Item Title: CSP #22-148C Lucio MS HVAC Upgrades, X Action
Phase I (Package 1) Project Information
Substantial Completion Discussion

Punch List

Final Commissioning Report

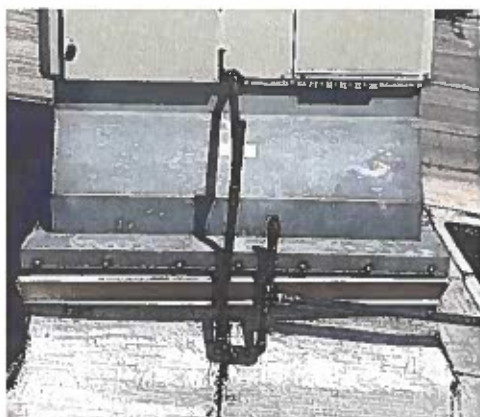
ITEM NO.	LOCATION (AREA)	DESCRIPTION	COMPLETION DATE	A/E CHECK DATE
1.	Main Roof	<ul style="list-style-type: none">The General Contractor shall confirm all RTU curb adapters and curbs are properly weathertight.The General Contractor shall fix all condensate drain lines as per the mechanical detail shown on the plans. Currently, most units are missing vents on p-traps.DOAS – Confirm all condensate lines are correctly connected to the equipment. Condensate water is present around the unit.The General Contractor shall provide a new set of air filters. The filters provided are dirty.		
2.	Athletics	<ul style="list-style-type: none">The General Contractor shall confirm all RTU curb adapters and curbs

ITEM NO.	LOCATION (AREA)	DESCRIPTION	COMPLETION DATE	A/E CHECK DATE
		<p>are properly weathertight.</p> <ul style="list-style-type: none"> The General Contractor shall confirm that all P-traps were installed as per the mechanical detail shown on the plans. The vent closer to the unit should be closed to avoid bringing unconditioned outdoor air. The General Contractor shall provide a new set of air filters. The filters provided are dirty.

3.	Offices and Choir Roof	<ul style="list-style-type: none"> The General Contractor shall confirm all RTU curb adapters and curbs are properly weathertight. The General Contractor shall confirm that all P-traps were installed as per the mechanical detail shown on the plans. The vent closer to the unit should be closed to avoid bringing unconditioned outdoor air into the space. The General Contractor shall provide a new set of air filters. The filters provided are dirty.

4.	Attic Space	<ul style="list-style-type: none"> The General Contractor shall confirm that all VAV boxes and duct penetrations through the wall are weathertight sealed.
